Rev. 01		SOS Coil Driver Module		LIGGS	
Date: D		Doc Number: D010001		Rev: PCB Revision: 01	
Title: 40m SRM Driver Module		Author: J. G. G. G.		Date: 11/05/17	
Project: 40m SRM		Engineer: J. G. G. G.		Date: 11/05/17

Title		SOS Coil Driver Module		LIGO Laboratory California Institute of Technology Massachusetts Institute of Technology		LIGO [®]	
Size: B	DCC Number: D010001	SCH / PCB Revision: B	Engineer: J. Heefner	Date: 2-Jun-2002		Time: 10:31:54	
File: E:\head\ligo\users\jay\SOSDriver\RevB\SOSDriverRevB.Prj				Sheet 0 of 3

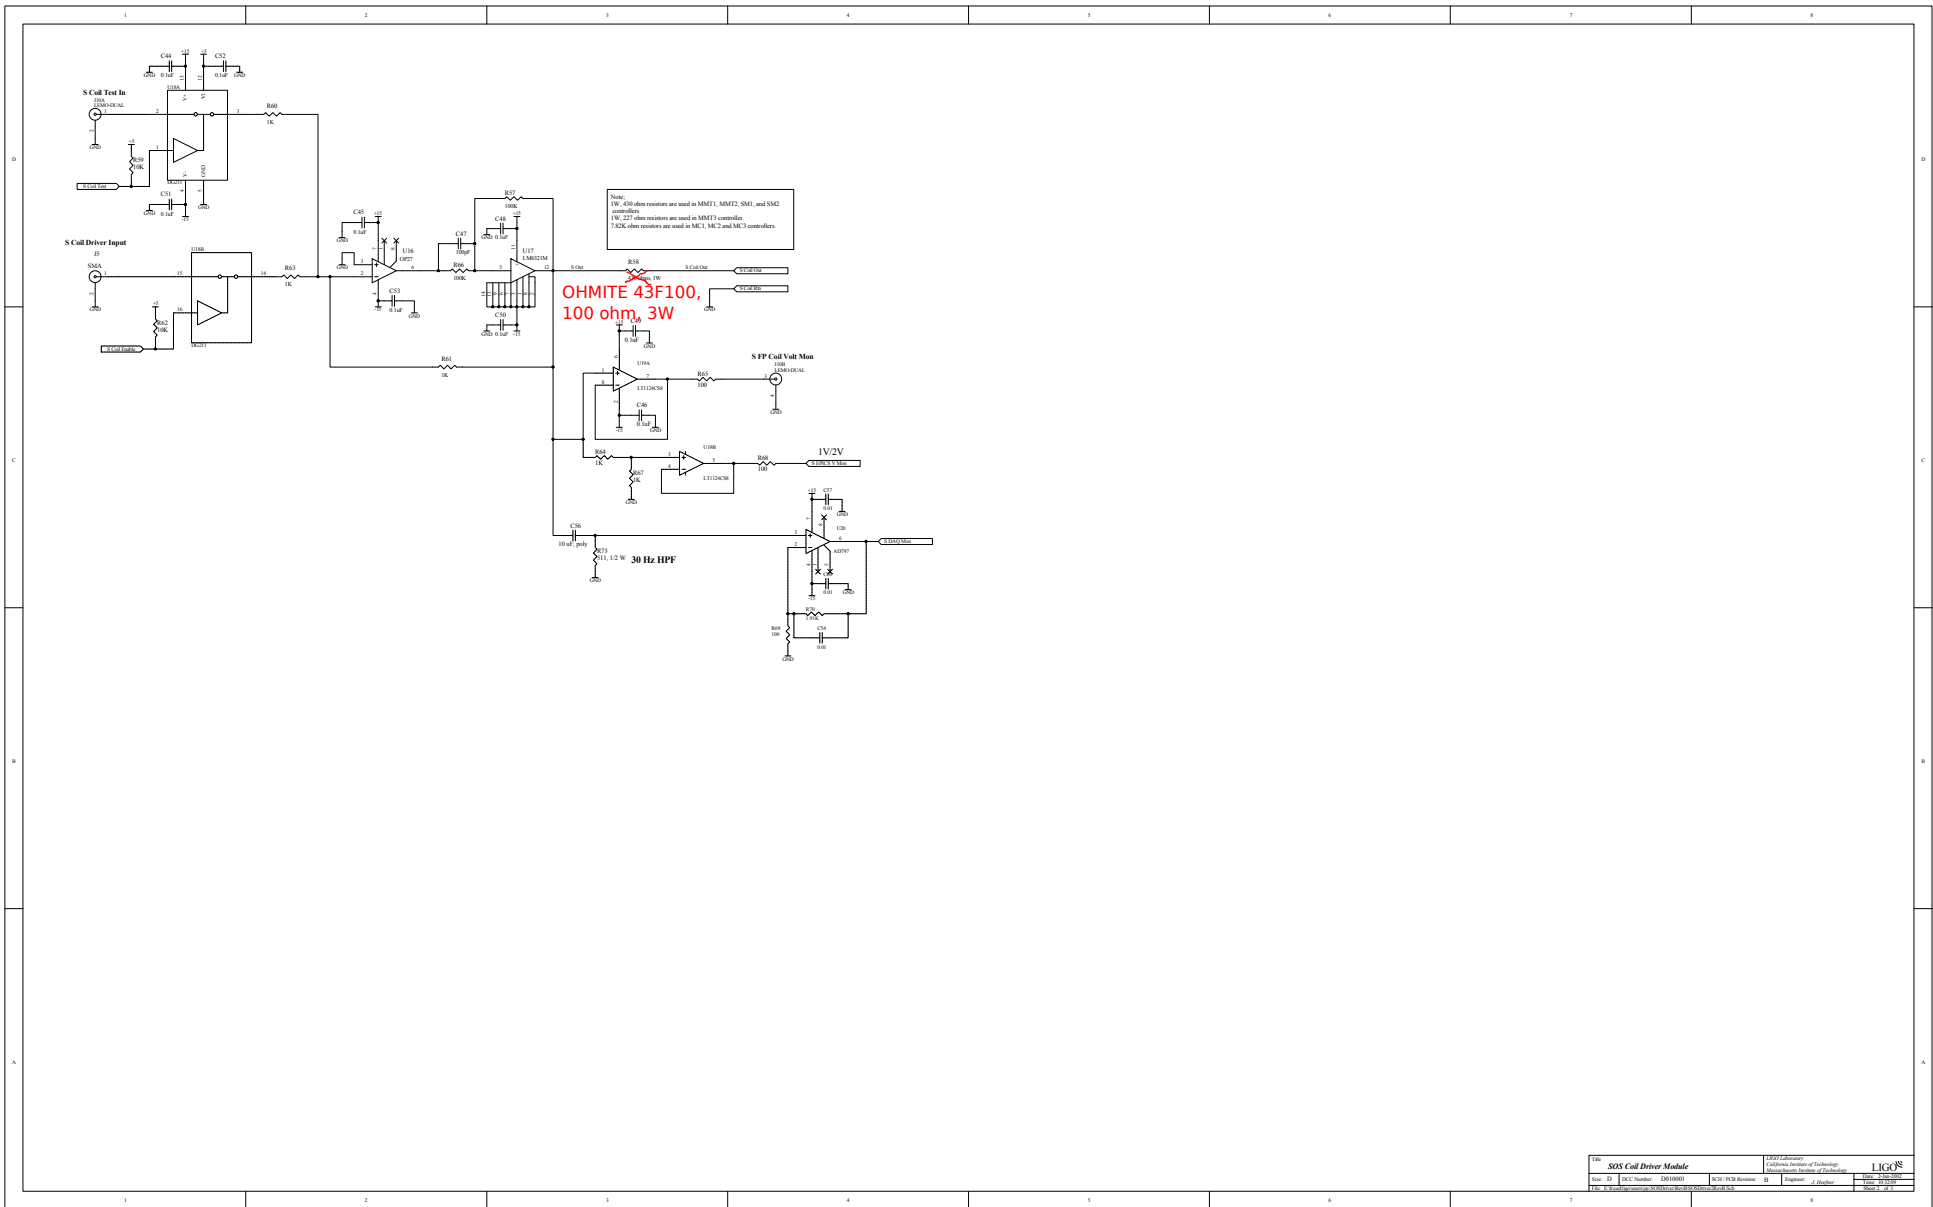
1. D010001-B, S/N B151, labelled "SRM"
 2. Used for 40m SRM
 3. "Test IN" LEMO inputs are used rather than SMA inputs, as latter are not switchable
 4. All deviations marked in **RED**
- GV, 11 May 2017

1. R2, R21, R29, R49, R58 from 100 ohm to 1kohm
2. Remove AD797s, U3, U5, U11, U15, U20
3. R77, R88, R91, R107 (bias path resistors) from 430 ohm to 1kohm
4. Remove Pots R97, R103, R112, R116, replace R99, R106, R113, R117 with 1kohm 1W for fast-servoing
5. Replace all thick-film resistors in signal path with thin film
